175-177 Cleveland Street and 1-5
Woodburn Street, Redfern

FINAL RESPONSE
TO SUBMISSIONS

State Significant Development 15_7064

Part 5 and Part 6 storey mixed use development with two
retail tenancies, hotel accommodation with 76 rooms and
a residential apartment building containing 19 apartments
(SSD 15_7064)

Figure 1:

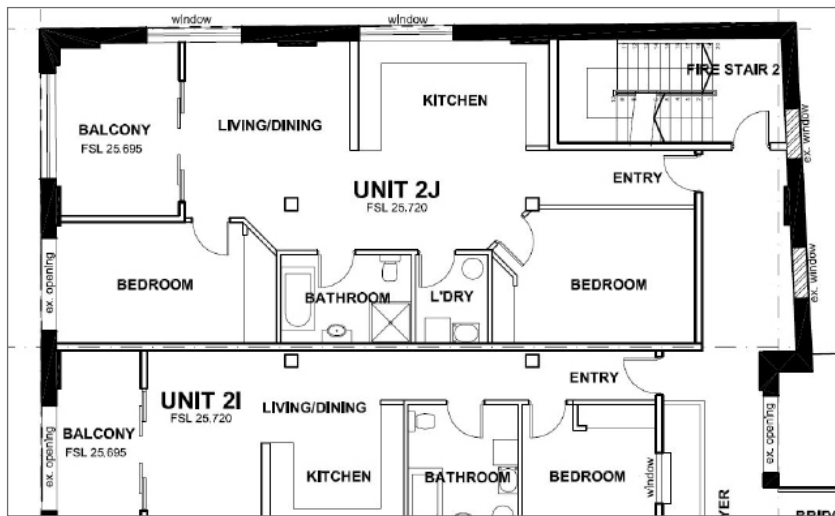
<p>6-8 Eveleigh Street</p> <ul style="list-style-type: none"> • Concern regarding the impact to the kitchen, living room and dining room windows in unit 9 facing the northern side boundary on level 2 which will be blocked by a solid bland wall running the whole length of the unit. • There will be considerable overshadowing over the common area on level 3, due to the proposed 5 levels building facing Eveleigh Street. 	<p>These issues have been addressed in response to concerns raised by the Department above.</p> <ul style="list-style-type: none"> • The southern adjacent building at 6-8 Eveleigh Street has windows in the boundary wall which face the subject site for Apartment 2J (Refer to Figure 1 below). However, these windows do not benefit from any legal entitlement or easement which would require the development of the subject site and any amenity gained via these windows is completely borrowed from the subject site.

Apartment 2J with windows on the northern boundary with the subject site with no legal entitlement. The living room also benefits from a primary living room window and balcony to Eveleigh Street
